RE: **Lot 5 Block 2 Unit 22 SAD 228**
8008 Canoncito Rd. NW
Volcano Cliffs Subdivision
Grading and Drainage Plan
Engineers Stamp Date 10/7/2025 (D10D003C5, HYDR-2025-00408)
Pad Cert Date: 11/14/2025

Based upon the information provided in your submittal received 11/24/2025, this plan is approved for Building Permit.

Grading Plan

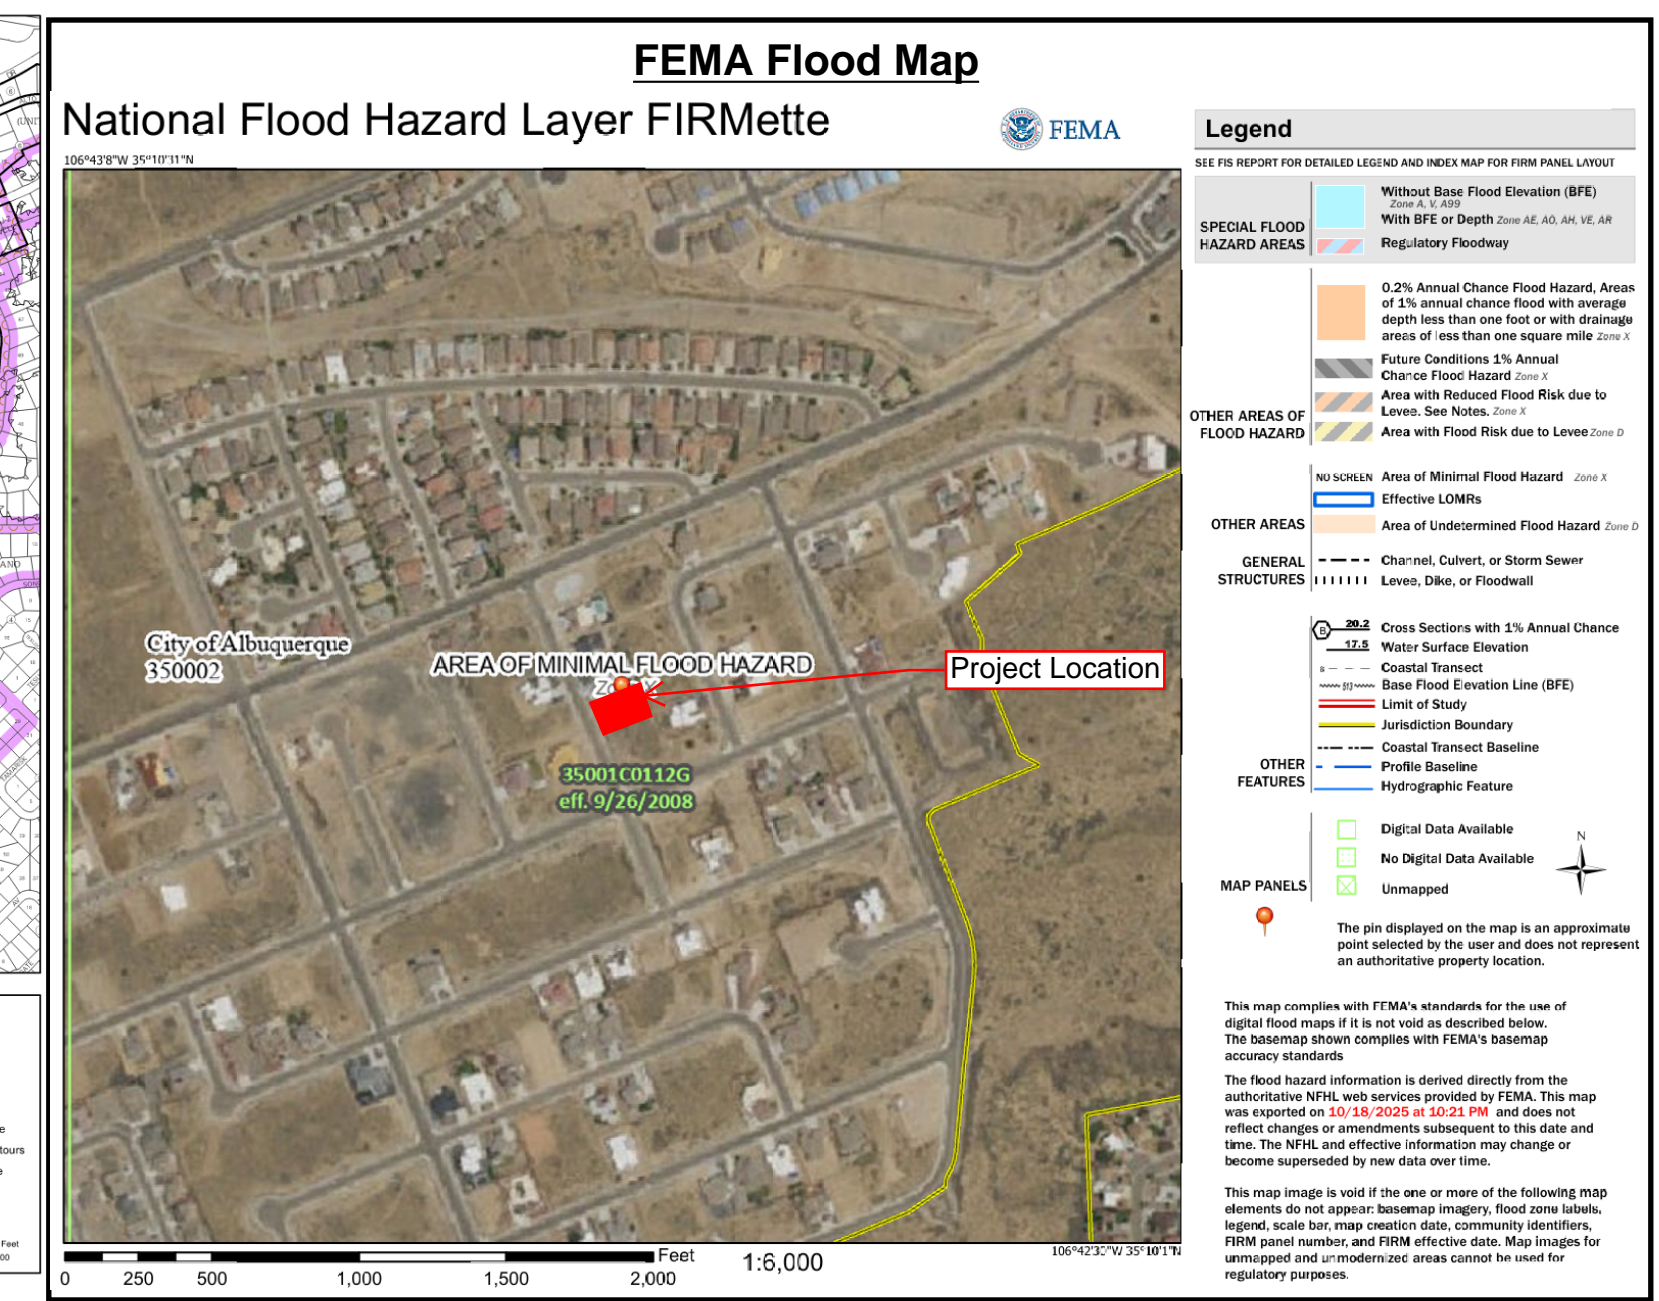
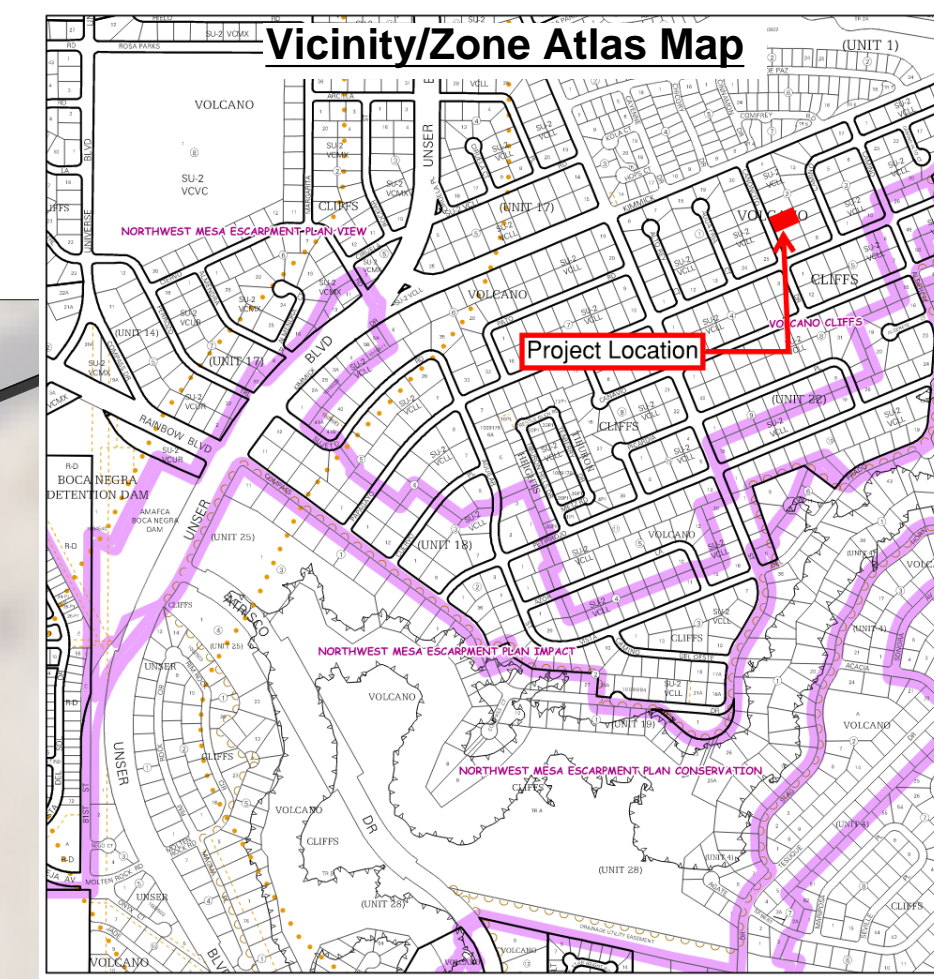
Advise the owner contractor not to use dirt as a ramp to climb the curb, use lumber or crusher fines for this purpose. Place this note on the plan.

Reiterate to the Owner/Contractor that a separate permit for a garden/retaining wall must be obtained with the approved G&D plan and Pad Certification. **Also, if a swimming pool is to be placed after this approval a new grading and drainage plan will need to be resubmitted showing the changes for the land treatments.**

Prior to Certificate of Occupancy release, Engineer Certification per the DPM checklist is required.
